Item Name: Dual High Back Seat, LH

DART SERVICE INSTRUCTION

TO AMEND INSTALLATION INSTRUCTIONS IIN-D350-689 REV. B
AND INSTRUCTIONS FOR CONTINUED AIRWORTHINESS ICA-D350-689 REV. 1

A	NEW ISSUE	MB	11.12.22
REV.	DESCRIPTION	BY	DATE
DESIGN		DART AEROSPACE LTD	
DRAWN		HAWKESBURY, ONTARIO, CANADA	
CHECKED		DRAWING NO.	REV. A
MFG. APPR.	N/A	DSI 9588	SHEET 1 OF 4
APPROVED		TITLE	SCALE
DE APPR.		INSTALLATION CHANGE	NTS
DATE	11.12.22	COPYRIGHT © 2011 BY DART AEROSPACE LTD	
THIS DOCUMENT IS PRIVATE AND CONFIDENTIAL AND IS SUPPLIED ON THE EXPRESS CONDITION THAT IT IS NOT TO BE USED FOR ANY PURPOSE OR COPIED OR COMMUNICATED TO ANY OTHER PERSON WITHOUT WRITTEN PERMISSION FROM DART AEROSPACE LTD.

FIGURE 1: UPDATES TO FIGURE 21 (IIN-D350-689) AND 25-21 (ICA-D350-689)

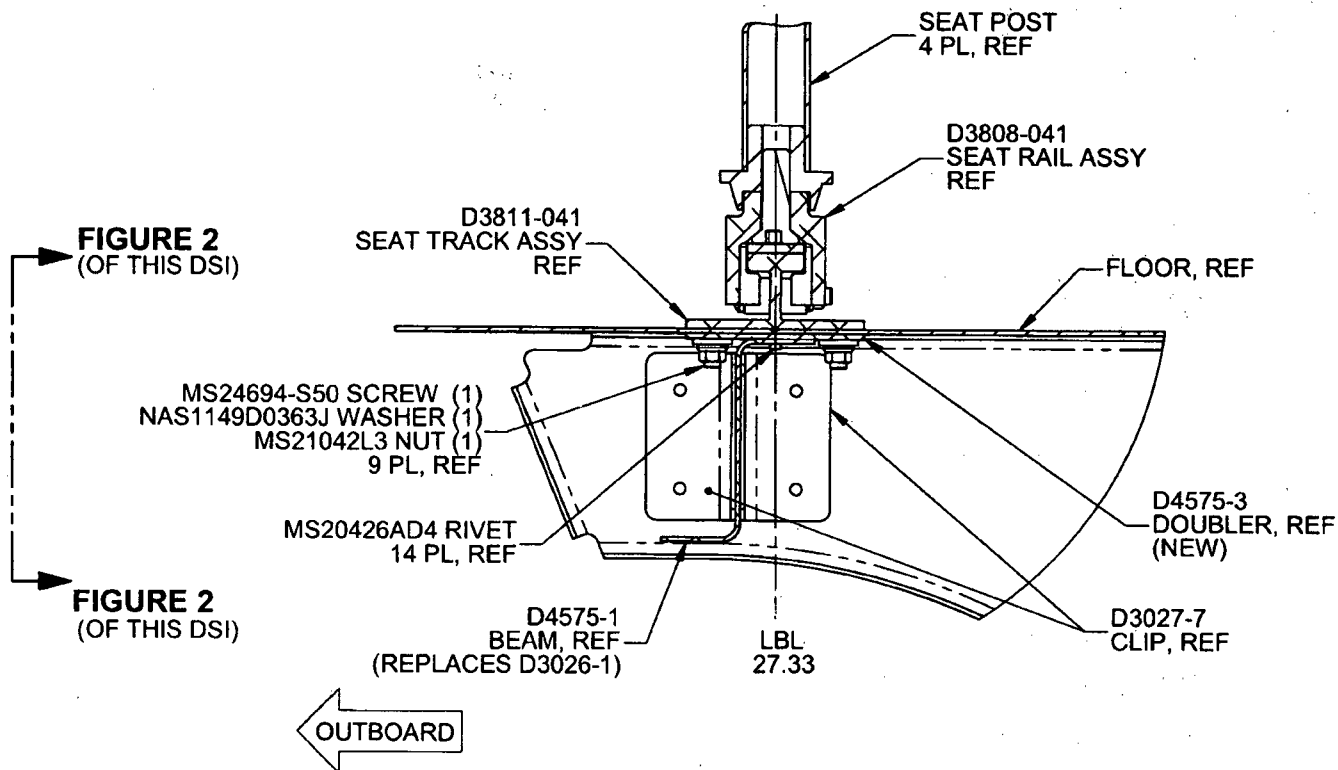
For D350-689-021/-023 Kits at CHG 005/004 and later, the D3026-1 Channel has been replaced with the D4575-1 Beam and D4575-3 Doubler and the D3234-3 Doubler has been removed. Consequently, the installation instructions for D350-689-021/-023 at CHG 005/004 are updated per Section 2.0 of this Service Instruction. The parts list update is shown in Section 4.0 of this Service Instruction. There is a negligible change to the weight and balance.

If there is an existing stringer at LBL 27.33, it will need to be removed from that location. Locate D4575-1 Beam and D4575-3 Doubler as shown in Figure 1 of this Service Instruction. Transfer drill existing holes from the aircraft floor to the D4575-1 Beam and D4575-3 Doubler. Ensure 1.0" to 1.5" rivet pitch and add additional holes if required. If there is no existing stringer, locate D4575-1 Beam and D4575-3 Doubler as shown in Figure 1 of this Service Instruction and drill Ø0.128" holes on a 1.0" to 1.5" pitch.

If there is an existing stringer at LBL 27.33, it will need to be removed from that location. Locate D3026-1 Channel as shown in Figure 4 and transfer existing holes from the aircraft floor to the D3026-1 Channel. Ensure 1.0" to 1.5" rivet pitch and add additional holes if required. If there is no existing stringer, locate D3026-1 Channel as shown in Figure 4 and drill Ø0.128" holes on a 1.0" to 1.5" pitch.

Attach D4575-1 Beam and D4575-3 Doubler to floor using qty (14) MS20426AD4 rivets.

Attach D4575-1 Channel to floor using qty (14) MS20426AD4 rivets.

FIGURE 2: RELIEFS ON D4575-1/-3
(ONLY D4575-1/-3 SHOWN FOR CLARITY)
VIEW LOOKING INBOARD

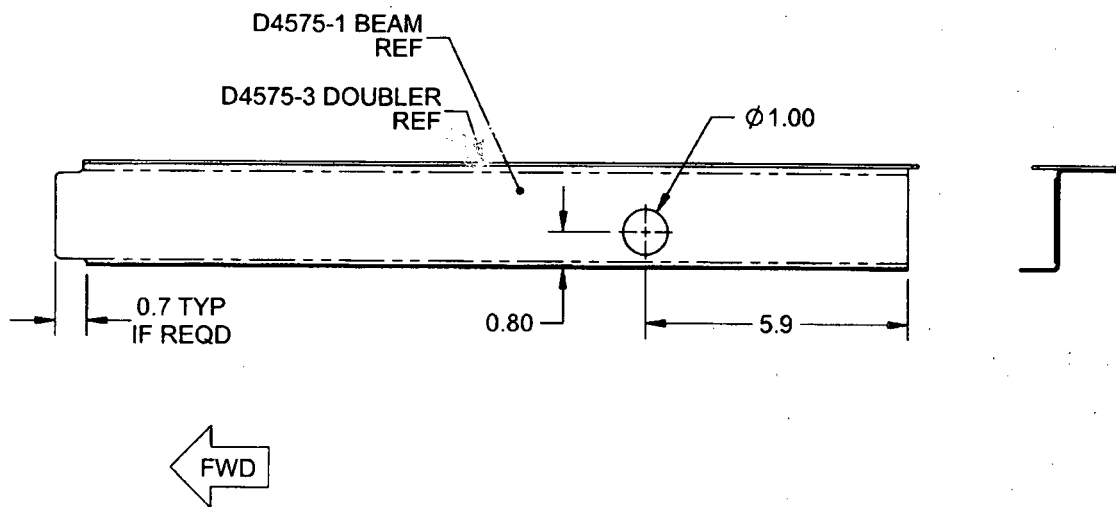
Note: Drill a Ø1.00" (Ø25.4 mm) hole in the D4575-1 Beam to clear extension tube of collective and cutout as required for clearance of collective opening and fwd bulkhead as shown in Figure 2 of this Service Instruction.

TRANSFER EXISTING CUTOUT
FROM AIRCRAFT FLOOR A/R TO
D4575-1/-3 FOR COLLECTIVE OPENING
